LAND AT BIRD IN EYE FARM, UCKFIELD

ARBORICULTURAL RESPONSE NOTE TO COMMENTS ON HIGHWAY ACCESS

APPEAL REF: APP/C1435/W/22/3307820

DATE: 6TH SEPTEMBER 2023

RPA COVERAGE PLAN (BHA_741_04)

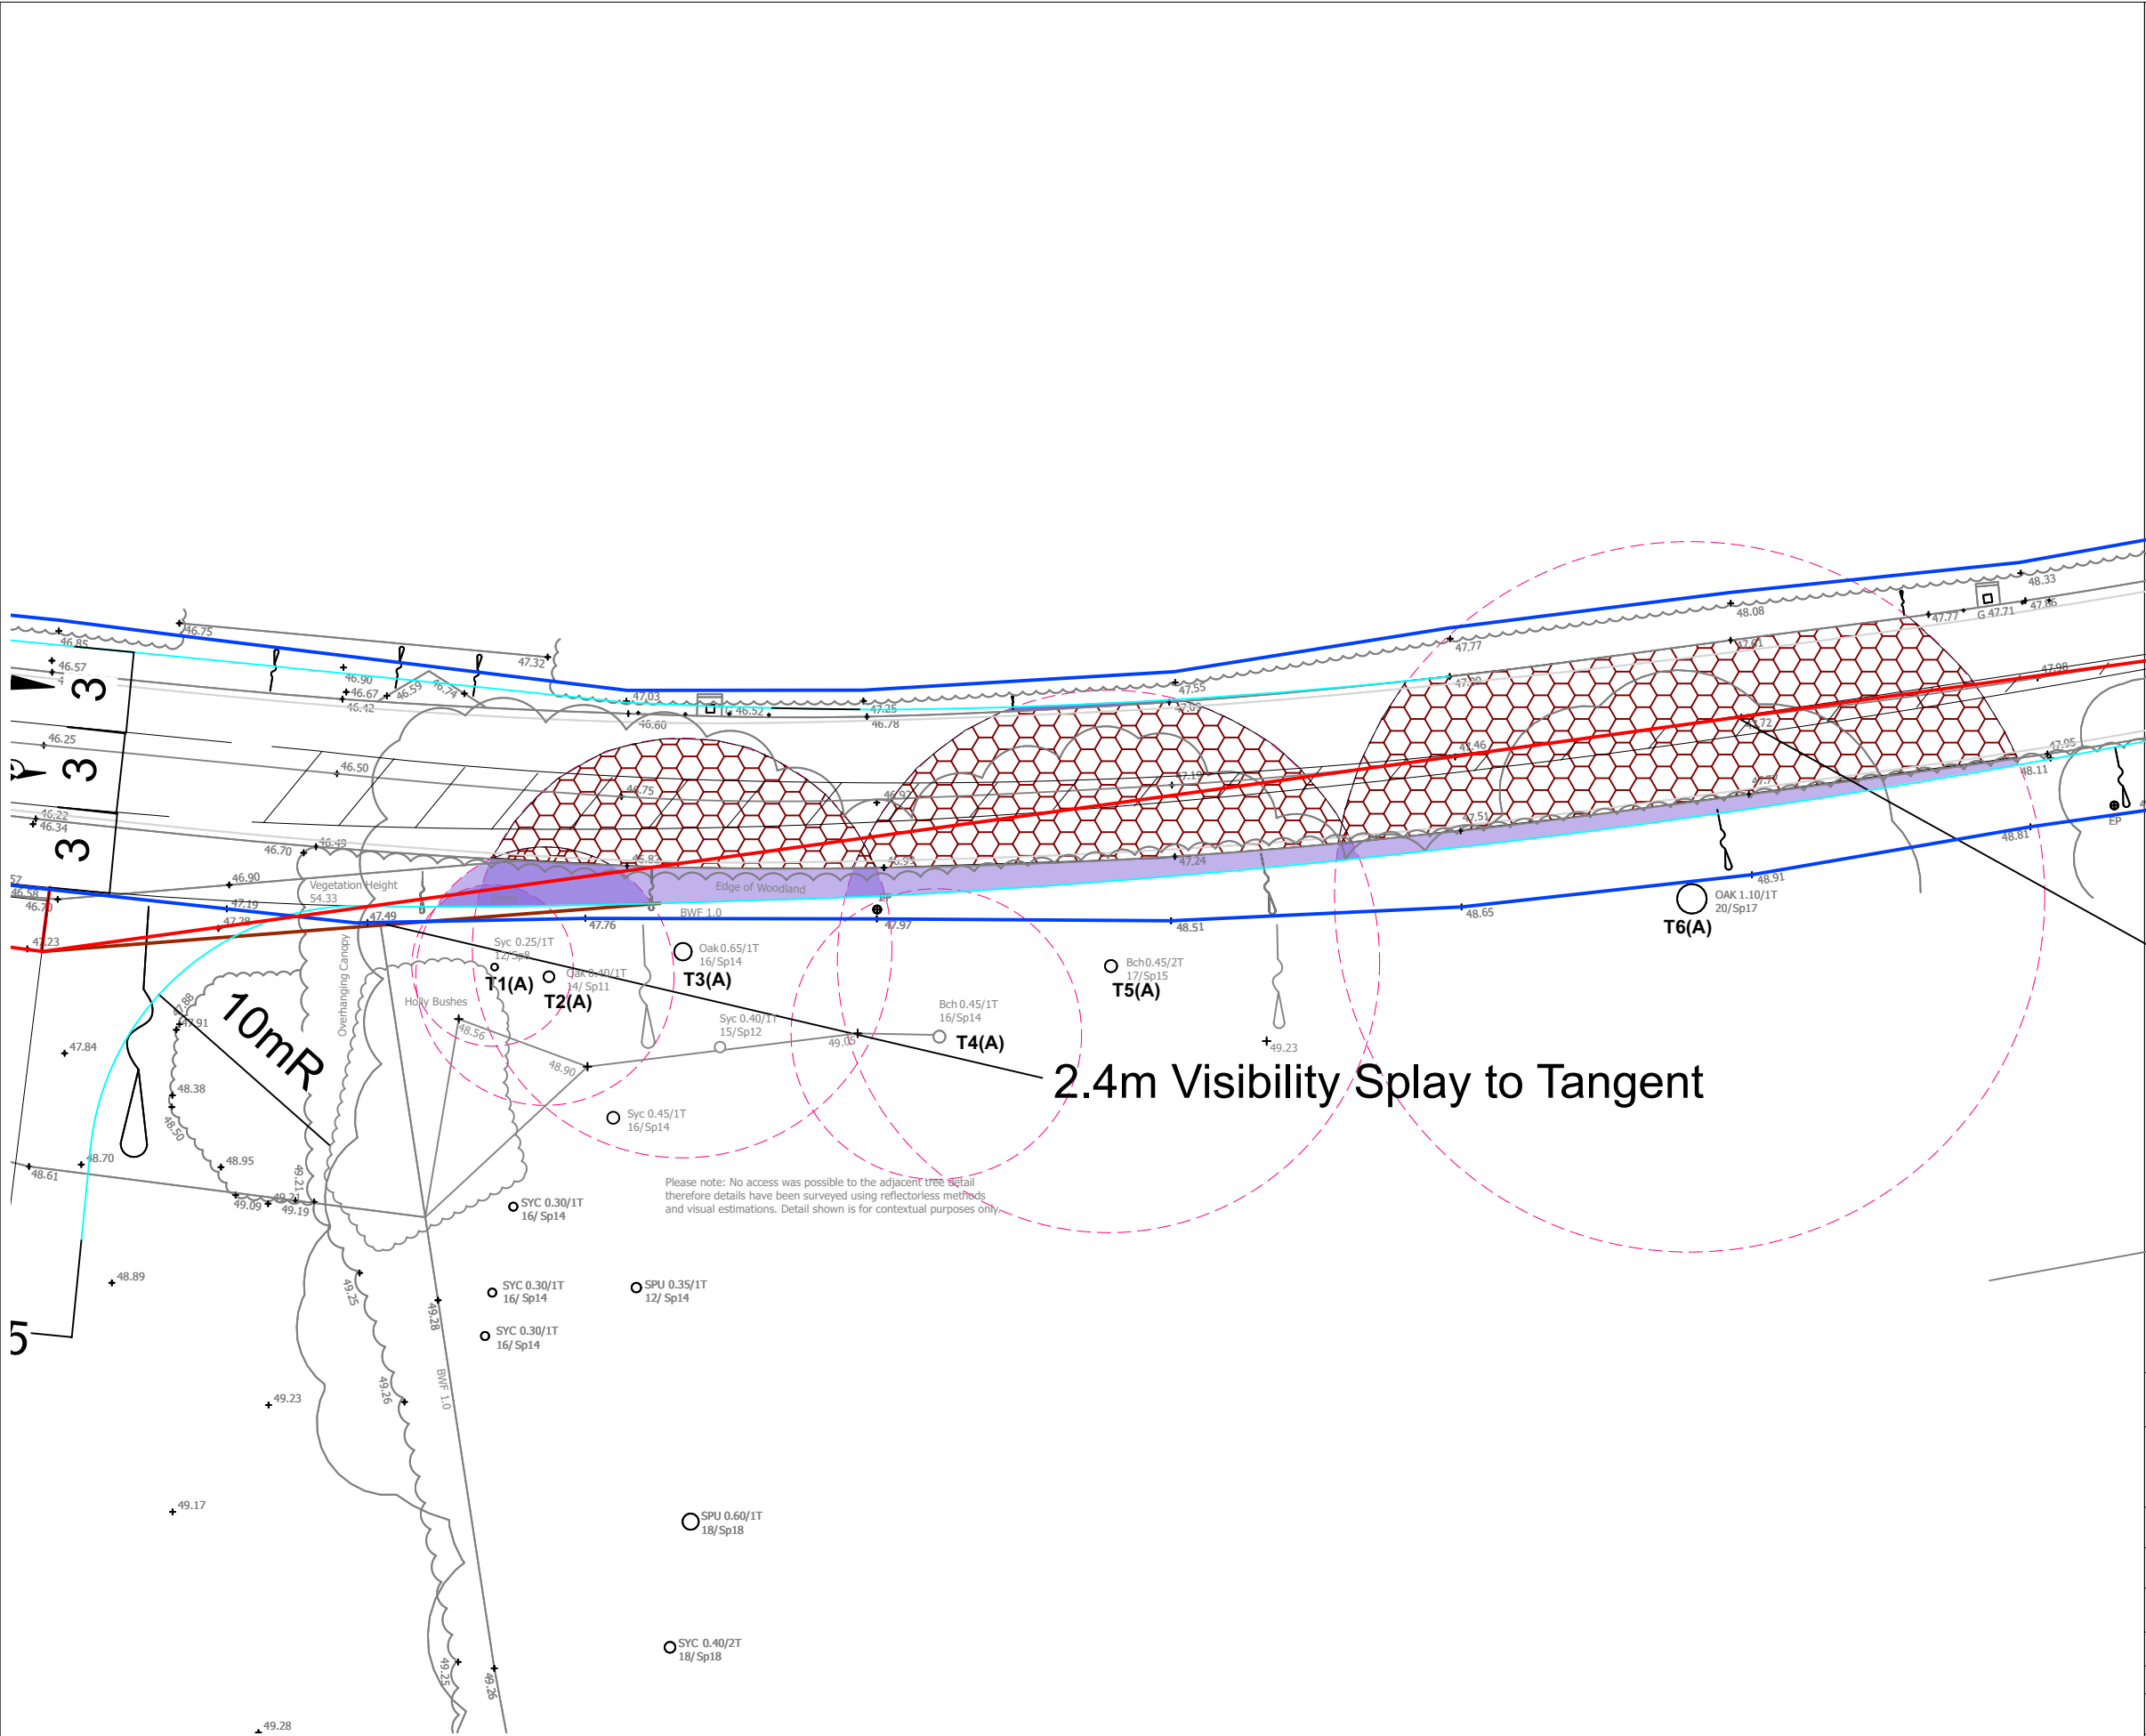
- 3.1. Within the 'Arboricultural Rebuttal Note' Mr. Rainbow refers to the potential effect of the proposed access works the stability of the adjacent trees whilst also acknowledging the Common Law right with regards to overhanging branches and encroaching roots. Mr Rainbow refers to the future stability of the trees potentially being affected if, as highlighted in paragraph 7.4.2.3 of BS5837:2012, 'New permanent hard surfacing should not exceed 20% of any existing unsurfaced ground within the RPA'. To assist in the assessment of this, and to understand if the proposed access meets this requirement, the plan at Appendix 1 (BHA_741_04) has been produced. This plan shows the RPA's, the existing hard surfacing, and the proposed hard surfacing. The results show that that none of the RPAs associated with T1(A) to T6(A) will have more that 20% of their unsurfaced RPA covered by new hard surfacing. These findings are also summarized in Figure 3 below.

- 3.2. As part of the detailed design it will be necessary to ensure the stability of the bank is not compromised in this location. This will be done by carrying out works with highway owned land only; where there are no significant trees present. Mr Twinberrow has advised that the new bank will not require any retaining structures and that the gradient of the new bank can be reduced by utilising techniques such as double height kerbs; should this be required. In addition, and if required through the detailed design process, it is also possible to install a low impact 2d geo grid system (or similar) over the new bank to aid its integrity. Such a system could be installed without impacting upon the roots of the adjacent trees and vegetation.

- 5.5. The proposed hard surfacing adjacent retained trees does not exceed the 20% limit of RPA coverage set out in BS5837:2012. However, it is important that the specific details of tree protection and arboricultural working methods (to be based on the finalised and approved access arrangement) are prepared and adhered to. As is commonplace with outline applications of this nature, and where offsite highway works are required via the Section 278 process, the matters of tree protection and working methodologies are agreed at Reserved Matters stage and through the Section 278 technical approval process. This approach is line with the process set out in BS5837:2012 that recommends the detailed/technical design of tree protection and arboricultural methodologies should be resolved and finalised following on from the approval of the feasibility of a scheme by the Local Planning Authority.

ACCESS PRUNING PLAN (BHA_741_05)

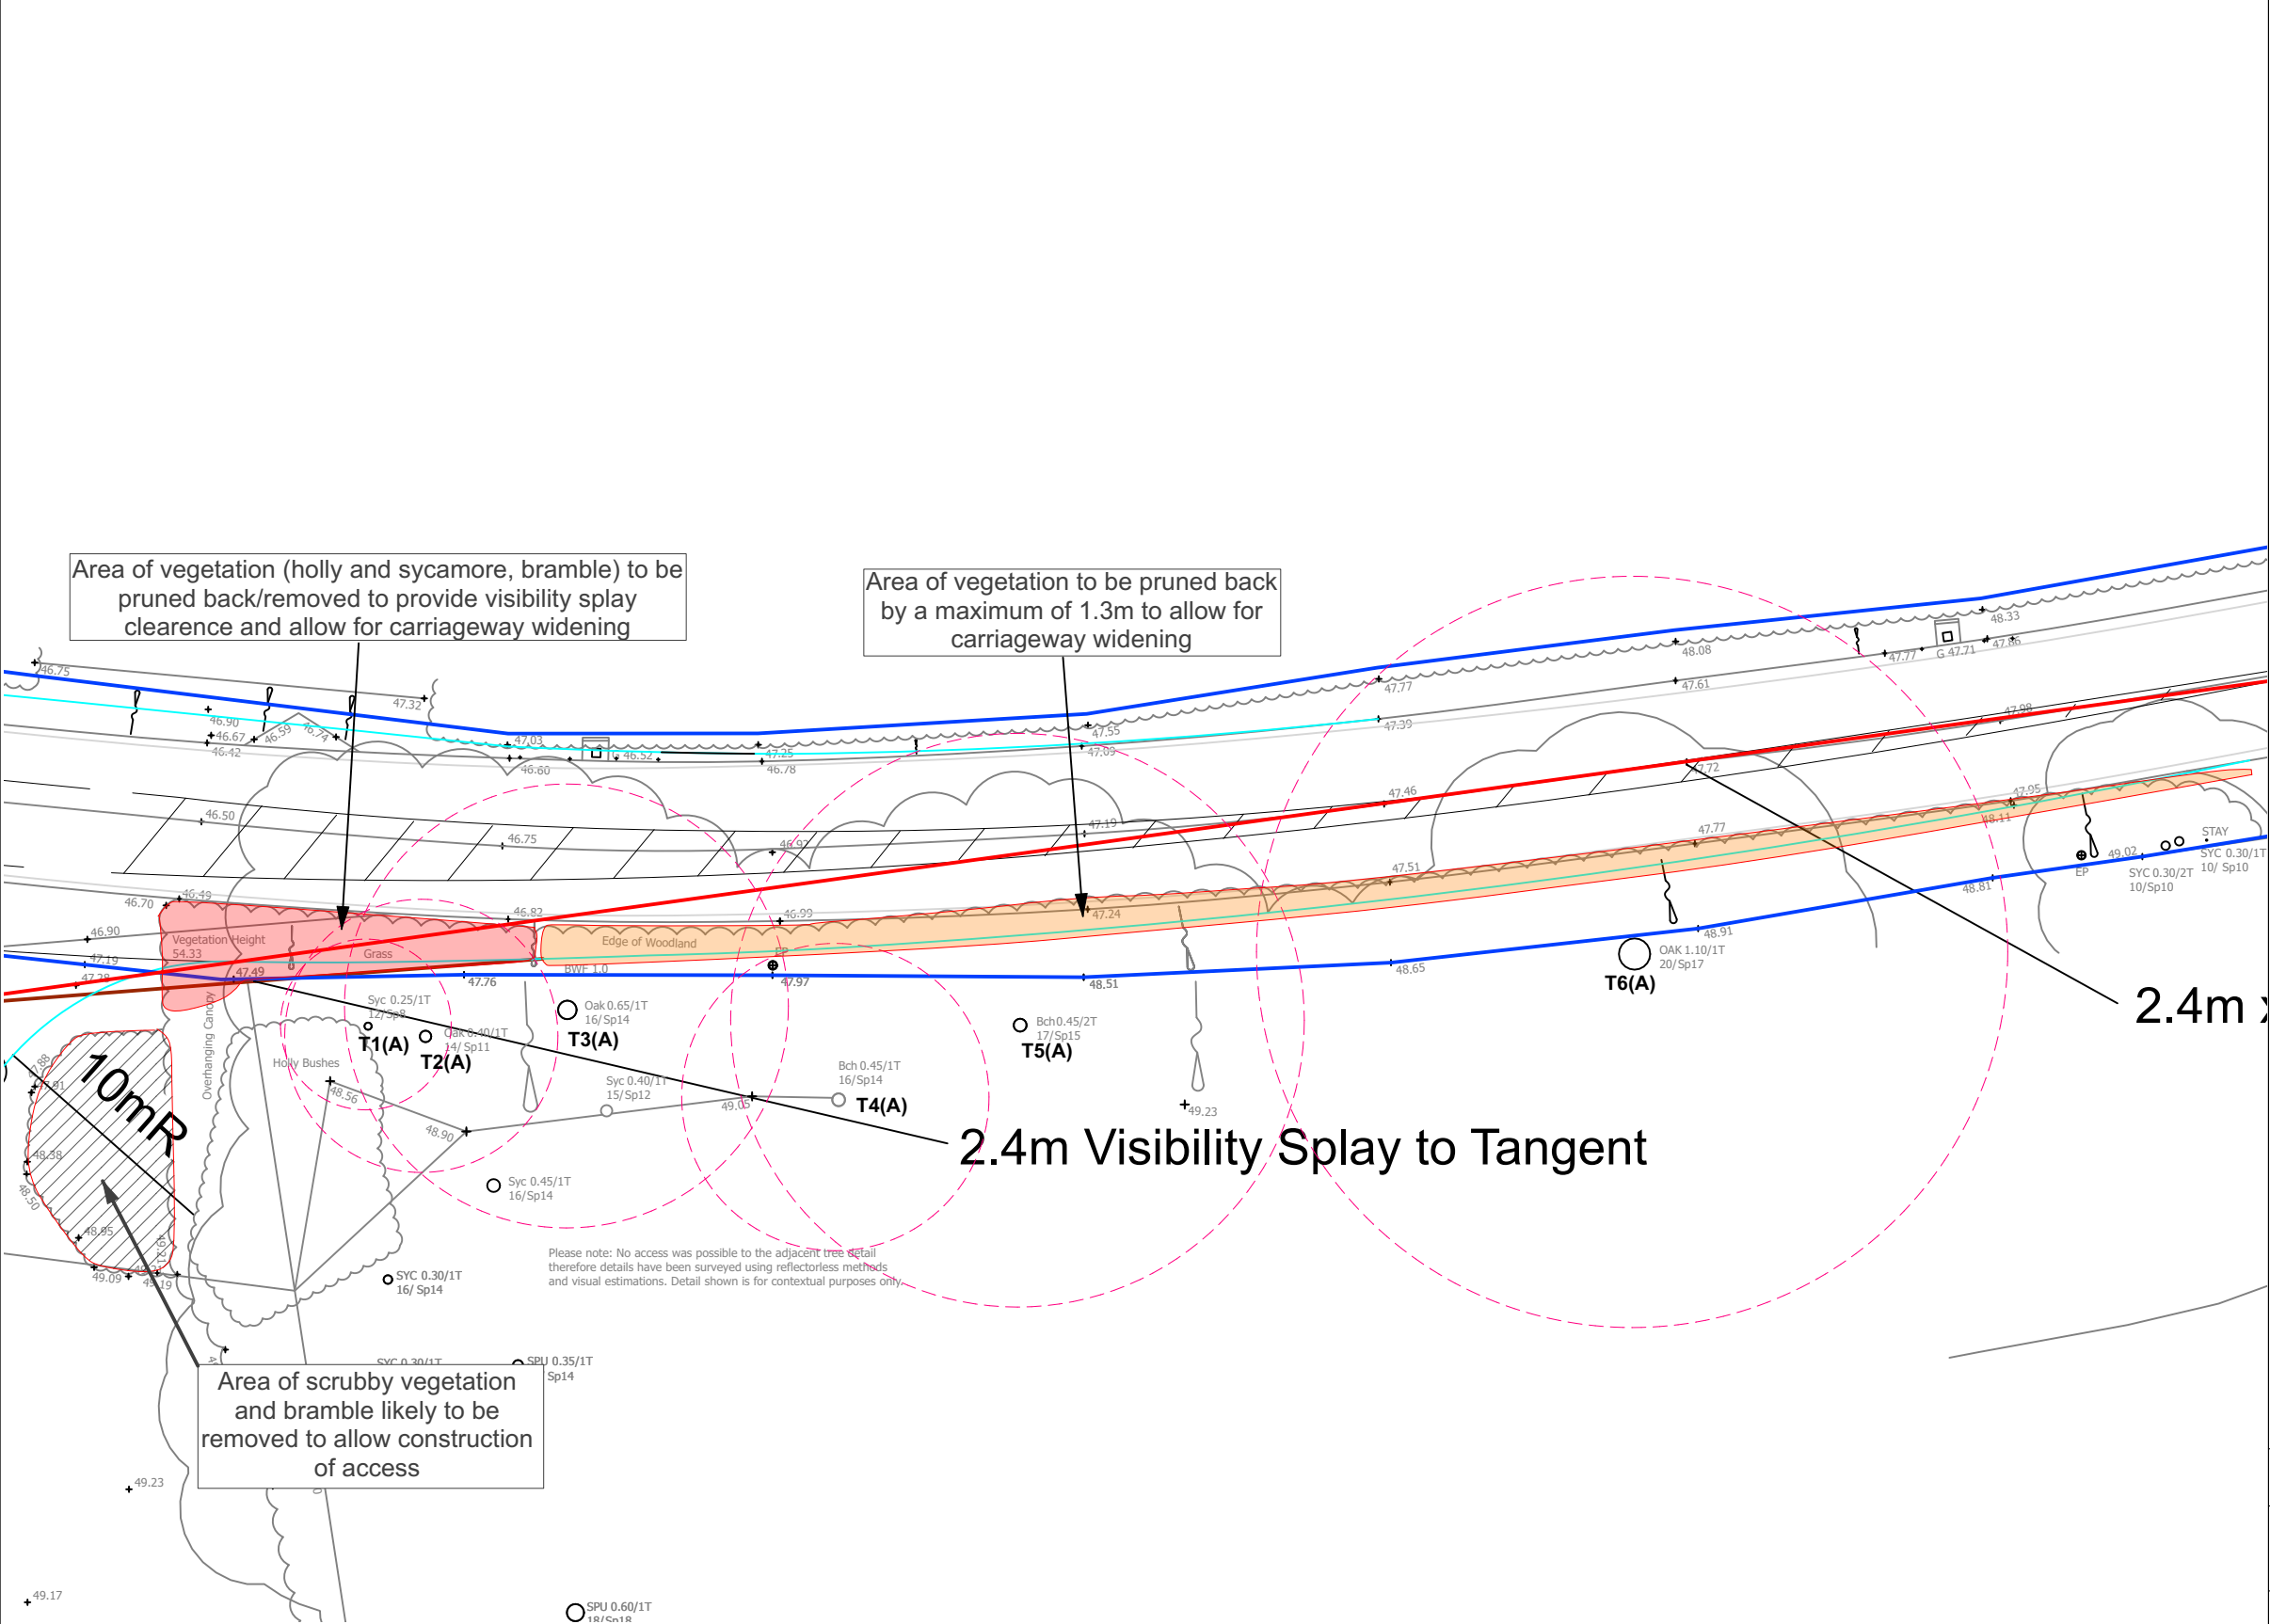
- 1.2. Mr Rainbow raises concerns regarding the impact of the proposed highway access from the B2102. I seek to address those concerns within this document.

- 4.7. To achieve the required visibility splay to the east of the access some vegetation removal and pruning will be required. This is comprised of a 13m long area of vegetation alongside the existing carriageway and that will require pruning back to the highway ownership boundary. (as shown in red on the plan in Appendix 2). This will also result in the removal of some small stems of holly and sycamore that are also present in this area. These are small stems that are insignificant in arboricultural terms.

- 4.8. Beyond the work required for the visibility splays, it will also be necessary to prune back the vegetation along the existing carriageway to allow for the carriageway widening (as shown in orange on the plan in Appendix 2).

- 4.9. Lastly, it is likely that the small area of scrubby vegetation, formed by birch, bramble and holly, to the immediate east of the proposed access (as shown by a cross hatch on the plan in

Appendix 2) will also likely require removal to allow for the construction of the access. Again, these are small stems that are insignificant in arboricultural terms.
